Memorandum

Subject: Riva Townhomes, SDP16-00004

In response to the DC's and public's questions and comments at the March 9, 2016 Public Hearing, Staff is providing the following Briefing Response Memo. This memo also incorporates public comments submitted to staff and the Development Commission after the first meeting and prior to March 30, 2016. The public comments are provided as Attachment 4.

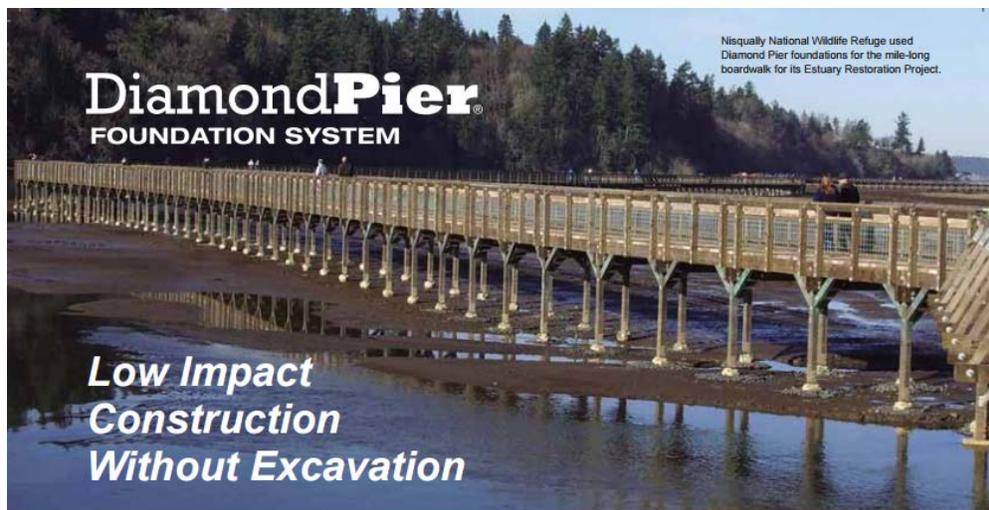
- 1. Shared Use Route:** There are no new commercial uses along this side of Newport Way so what destinations will the Shared Use Route along Newport Way link to? Where will the Shared Use Route along the northern perimeter of the property connect to? A bridge across

Will the Shared Use Route be located in the Riva property or the Sammamish Pointe Condominium property? It is too close to the backyards of the Sammamish Pointe Condominium residences. There is no fence or any barrier shown between the Riva property and the Sammamish Pointe Condominiums residential backyards - concerned about the loss of privacy and littering along the Trail. Why not locate the trail at the southern end of the property?

Since the proposed development is primarily wetlands, we should respect the land and minimize destruction - strongly oppose the location of the multi-use trail in the wetlands. What is the impact to the wetlands and wetland buffers of adding this boardwalk in the critical areas? The CIDDS sec.10.11 (E) prohibits removal of trees in critical areas, except as allowed in the Land Use Code, IMC18.10. Will the Shared Use Route require removal of trees? By what provision in the code? If so, how many trees will be removed? Will the Shared Use Route be located so as to avoid the critical root zones of existing trees to be retained? What is the process for reviewing the Shared Use Route in the critical area, i.e. choice of location over blackberries or removing trees? Is there a Tree Retention Plan for the public to review prior to Development Commission approval?

There are two Shared Use Routes required for this development. For clarity, the Shared Use Route along Newport Way will be described in this Briefing Response Memo as the "Shared Use Route on Newport Way" while the Shared Use Route that runs in the interior of the Riva property and continues off-site to the boardwalk of the Gateway Apartments' boardwalk will be called the Riva-to-Gateway Shared Use Route. To facilitate the Development Commission and the public's understanding of the connections for the Shared Use Routes, a regional map showing other trails in the Western Gateway is provided (see Attachment 3).

The Shared Use Route on Newport Way replaces the existing on-grade 10-foot wide multi-use trail on the east side of Newport Way. The Shared Use Route will be an improvement to the existing pedestrian facility, since it will be raised and separated by a 5-foot landscape strip with street trees, thus providing a safer facility for pedestrians and bicyclists. The Shared Use Route will connect the residential areas along Newport Way to the Transit Center and the new neighborhood park north of Sammamish Pointe Condominiums, through the park access at the intersection of Pacific Elm

Staff and the Applicant have continued to refine the condition for the location for the Shared Use Route along the northern perimeter of the property. In response to the public comments and Development Commission input, the recommended conditions have been revised to implement a connection to the future boardwalk associated with the Gateway Apartments. The other alternative, to connect east to the Rowley Properties, has been determined infeasible, due to the lack of interest from the Rowleys to provide a connection at this location.

The Riva-to-Gateway Shared Use Route connects the Shared Use Route at Newport Way to the boardwalk in the Tibbetts Creek wetland associated with the Gateway Apartments project (Gateway boardwalk). The Riva-to-Gateway Shared Use Route follows the boundary line between the Sammamish Pointe Condominiums and the Riva property and continues north through the Tibbetts Creek wetland area in the Gateway Apartments' property, up to the Gateway boardwalk. The proposed trail will consist of a hard-surface on-grade trail outside of the wetland areas, and an elevated

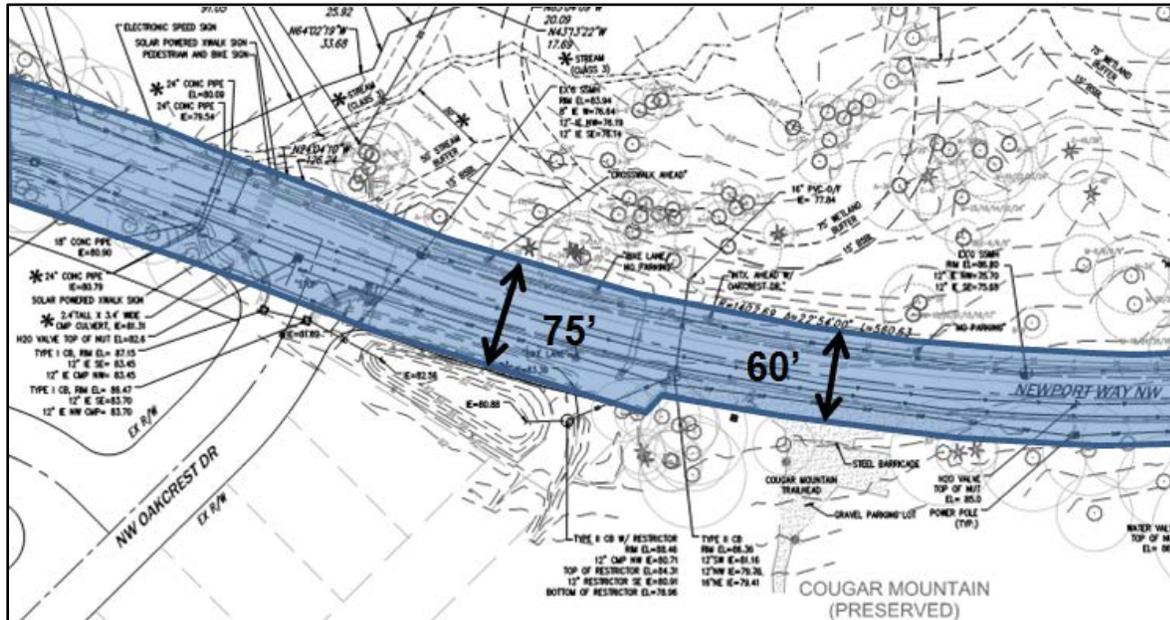
Will the median along Newport Way inadvertently limit the access to the Cougar Mountain Trailhead to right-in right-out only? The Issaquah Alps Trail Club has always advocated for access from the Transit Center, and new users from the Bergsma property should be considered also. It would be a big mistake to require trail users to go past Oakcrest and turn around to access the trailhead. The construction of the landscape median should be coordinated with the location of the future driveway of the trailhead. There should be a midblock crosswalk at Newport Way at the entrance to the trailhead.

The current width of Newport Way is 40 feet and the future width proposed is 67 feet. Where will the 27 feet come from? Will dedication of right-of-way be required for properties along Newport Way? Where will trail users park in the future, since the existing shoulder where they currently park, will be taken up by the roadway? Given all the new developments proposed along Newport Way, we need a traffic analysis for the whole corridor.

The final length and location of the center lane and median will be based on turn lane pocket lengths required to serve the intersection of Oakcrest and Newport Way. During the preparation of the construction permits for changes to Newport Way, sight distance evaluation and other safety consideration will occur. These evaluations might, if appropriate to meet sight distance requirements, alter the standard placement or spacing of trees, such as in those planned in the centermedian.

King County, which owns and manages the Cougar Mountain Wildland Park, is currently looking at trailhead improvements. This will be a multi-year process involving grant funding and development of design and construction drawings. City staff has met with King County Parks staff and discussed future improvements along Newport Way, how this will impact the trailhead, and opportunities for improving multi-modal access to the trailhead. A median break is in consideration for the trailhead access drive; however, the actual location of the break will be determined when the driveway access to the trailhead is determined. During construction permit review for the Riva project, City staff will work with King County staff to anticipate these possible future activities in their design of this segment of Newport Way.

To account for the shift in the roadway centerline towards the Cougar Mountain trailhead and the paving of the current shoulder to accommodate the eastbound travel lane, the Applicant will be required to provide a 5-foot paved shoulder to accommodate a pedestrian path to the trailhead from the crosswalk at Oakcrest Drive. This was a SEPA condition for the project. The gravel shoulder used for informal parking by trail users will be removed, consistent with the right-of-way improvements of other projects along Newport Way, since on-street parking on a Parkway is not consistent with the CIDDS standards and the City's Streets Standards for Newport Way.
